**BEFORE THE PUBLIC UTILITIES COMMISSION
OF THE STATE OF CALIFORNIA**

Rulemaking 14-07-002
(Filed July 10, 2014)

**COMMENTS OF PACIFIC GAS AND ELECTRIC COMPANY (U 39 E) ON DRAFT
VERSION OF THE NET ENERGY METERING PUBLIC TOOL**

Pricing: Tool Inputs and Market Reports (<10kW)

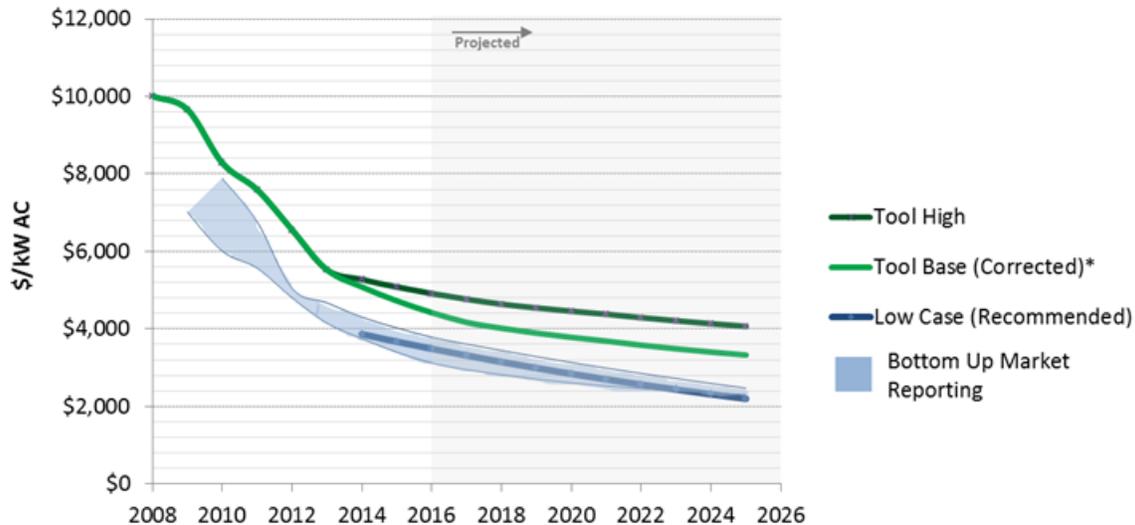
Solution: The drop-down menu in cell C26 of the “Key Driver Inputs” tab should offer users more than just “Base” and “High” price scenarios. It should include a “Low” price scenario. Moreover, the current Base scenario itself appears to represent the higher end of the pricing spectrum in California based on bottom up cost and pricing research. PG&E recommends E3 adopt the “Low” price scenario shown below (dark blue line), which could fairly be described as the “Base” scenario, since it is the mid-range of bottom-up market pricing research.

If the Draft Tool is run using this suggested price scenario (described as “Low Case” in the figure above) and the duplicative financing expenses are removed from the pro forma model (as explained in Issue 5 of Question 6), the Draft Tool’s results appear much more rational, although other errors in the model obscure the full impact of this change.

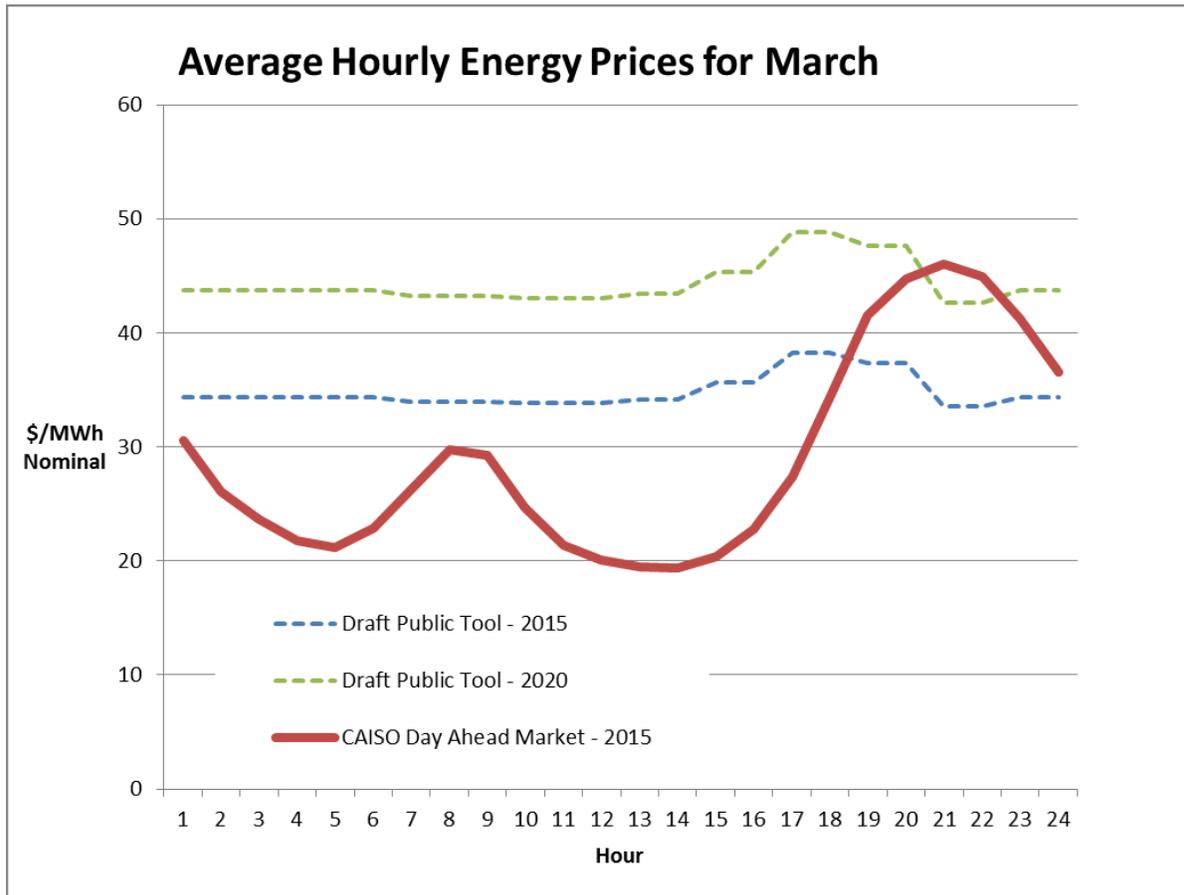
Issue 3: The simplified stack model produces energy prices which are too flat and too high in the middle of the day. This significantly overstates the avoided energy cost by up to 400% in 2020 and understates the cost-shift associated with solar PV.

Rationale: The comparison below between the Calculator price forecast for March 2015 and actual CAISO Day Ahead Market prices from March 2015 demonstrate that the simplified stack model produces prices which do not resemble the CAISO's "duck curve" and are significantly too high during the day. PG&E and other market participants anticipate that daytime prices will continue to fall as the amount of solar currently installed is more than doubled over the next 5 years, yet the simplified stack model continues to produce flat prices across much of the day in 2020. This flat price curve drastically over-values solar energy which results in an under-estimate of the cost-shift in the RIM test.

Solution: Calibrate the simplified stack of marginal heat rates for 2015-2020 such that monthly average hourly prices created in Calculator for recent months reflects the shape of actual monthly average prices from the CAISO day ahead market. Beyond 2020, PG&E recommends calibrating the simplified stack of marginal heat rates such that the monthly average hourly prices created in the Calculator reflect the shape of monthly average hourly prices observed in the 2014 LTPP PLEXOS 33% RPS and 40% RPS models, which are publicly available from the CAISO.

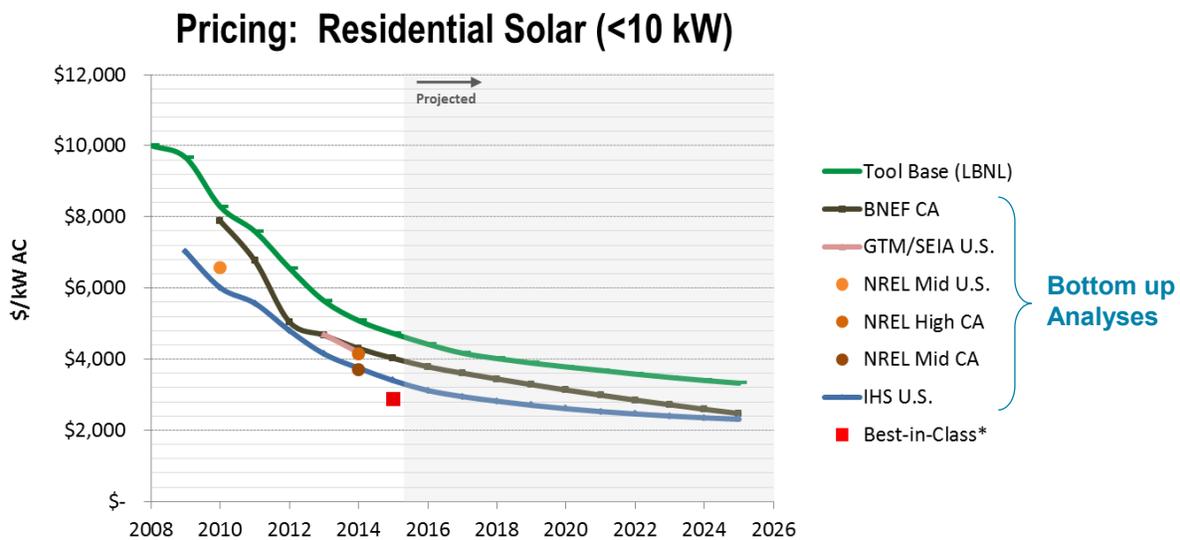
Issue 6: The Draft Tool’s “Base” solar pricing inputs represent the high end of the current pricing spectrum in California and are reflective of only a single study that uses a flawed top-down analysis method. The top down analysis method has been demonstrated to be less accurate than widely accepted bottom-up methods. This issue is distinct from the proposal to add a low-price scenario (Issue 1, Question 4) in that it addresses the basis for all scenarios modeled in the Draft Tool.

inflated and that the data offer an inaccurate perspective on actual market pricing.⁹ The Draft Tool currently references a single study that uses a top-down method to estimate solar market pricing – i.e., LBNL’s study is based on pricing reported to state incentive programs. *Given that the U.S. Department of Energy has funded NREL since 2011 specifically to provide a more accurate perspective on pricing through bottom-up analyses, and market reporting agencies such as GTM/SEIA, BNEF, and IHS have adopted this methodological approach, we recommend that the Draft Tool base its pricing information off a study that utilizes a bottom-up analysis method.*

Several reputable organizations have provided a strong rationale for why bottom up analysis methods are a more reliable indicator of actual costs and market prices. When GTM/SEIA transitioned to a bottom-up approach in 2013, they wrote the following: *“In an effort to ensure that the data reported is timely and accurate for industry assessments, we will be switching to a bottoms-up methodology based on tracked wholesale pricing of major solar components and data collected from major installers.”*¹⁰ The following year, GTM/SEIA emphasized the same point: *“As stated, these [top-down analysis] figures are subject to a number of factors that render the analysis insufficient for determining the actual industry costs during the quarter*

Solution: Include at least one reference from a report that uses a bottom-up methodology in developing the price scenarios.

Pricing: Commercial Solar (>10kW)

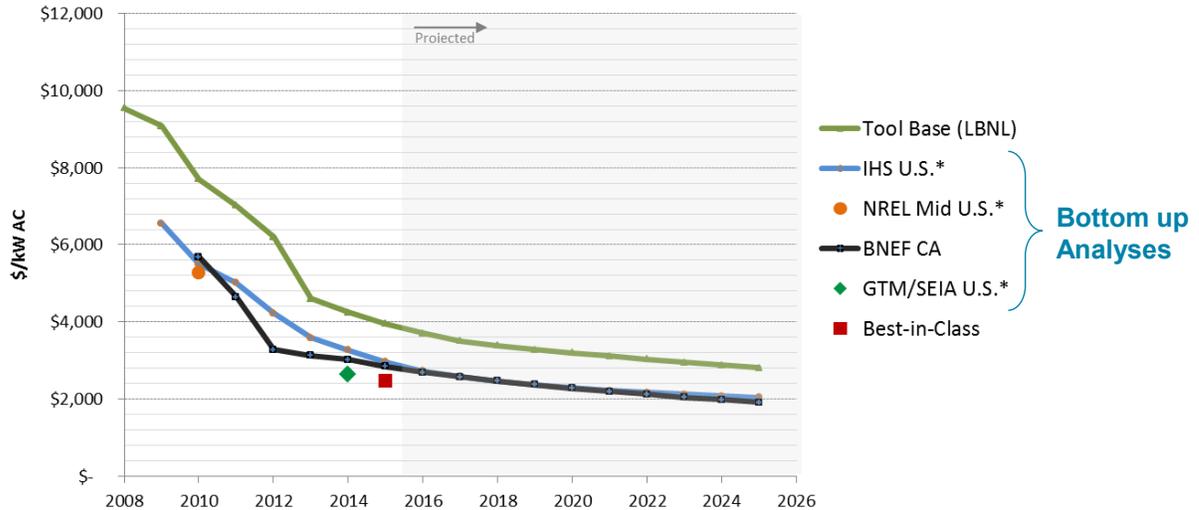
There is consensus as to both methodology and findings in various studies about the use of this bottom-up methodology, as illustrated by the charts below:

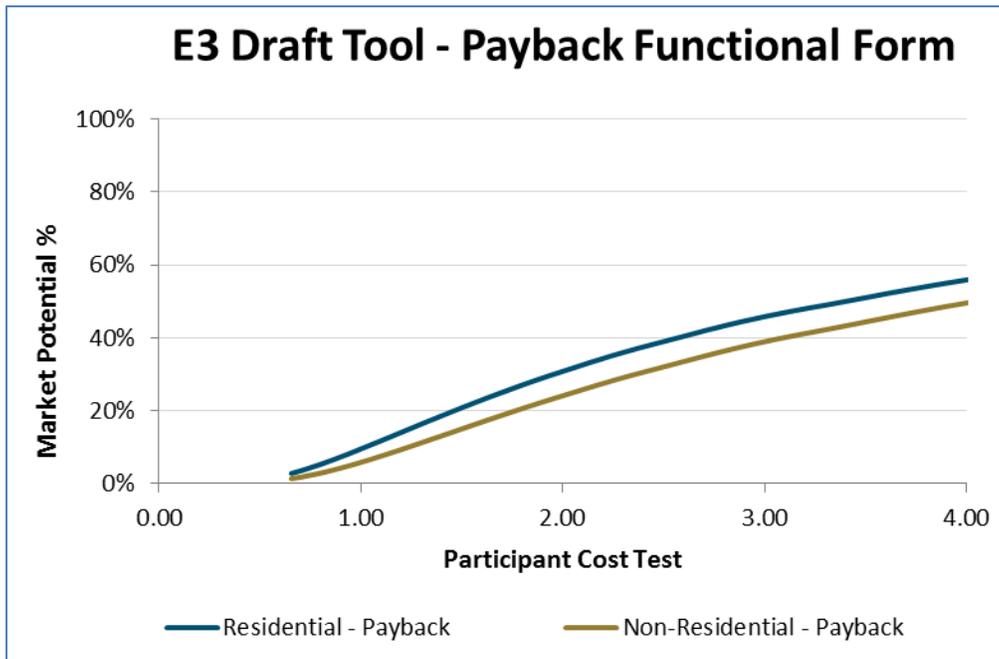
Issue 1: The adoption algorithm is based on a payback curve, which is based on outdated research and unrealistically limits adoption.

Description: The current version of the model uses a payback curve to determine the market potential of each DG technology. While the underlying economic calculation is a benefit-cost ratio, this is translated into a payback time, which is then translated into a market potential using the functional form $e^{m \cdot \text{payback}}$.

This methodology dates back to a paper regarding electric heat pumps (Kastovich 1982), which identified that many electric utility customers require very rapid payback times for investments that reduce utility bills. The implication of the study is that many customers use high internal discount rates for deciding whether to invest in energy saving investments, when faced with an upfront capital investment that is recovered over time via energy savings. Implicitly, if zero-down financing options (e.g., PPA/leases and some newer forms of loans) permit customers to avoid or reduce upfront costs and save money from day one, then the attractiveness of an energy saving technology would be much less sensitive to internal discount rates. This would result in increased market potentials at a given level of cost-effectiveness relative to the payback approach. In fact, this is exactly the phenomenon that has unleashed the recent, explosive growth in the PV market in California.

Solution: Implement a more representative “logit” based functional form to model customer decision making, per the instructions in Appendix B below. PG&E has implemented this solution in the draft Public Tool and found it to be a non-burdensome exercise.

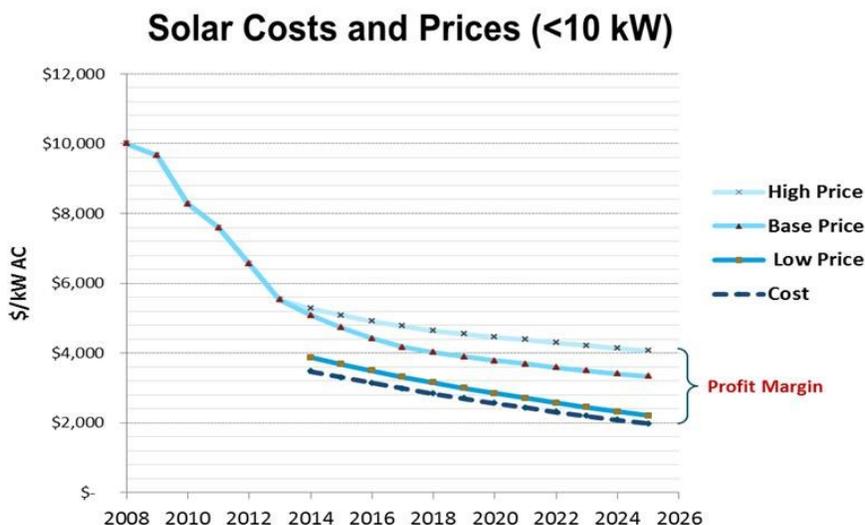
Rationale: Offering some perspective on costs and margins is essential. First, it will bound users’ low-end pricing estimates and eliminates irrational (or at least unlikely) pricing scenarios. Second, it will offer insights into whether DG vendors have sustainable market opportunities. Lastly, this simple addition would not change the core function of the model, yet it would provide a number of stakeholders with important insights for a range of policy and pricing scenarios.

The illustrative chart below reflects changes that could be made to the Tool. The Tool would not have to illustrate these curves – it currently just lists pricing in a table – but a supplemental chart that shows estimated margins (difference between cost and price) for different scenario would provide significant value to many stakeholders.

Solution: Add both a solar cost trajectory (as described in a previous comment), and insert a basic chart that offers users a visualization of estimated margins for given pricing scenarios (e.g., Base or High) that are already in the model. For example, if a user chooses the Base scenario, they could go to the Advanced Inputs tab and see the estimated margin in a simple figure that is generated by the difference between the costs and prices (for a given scenario) in the table.
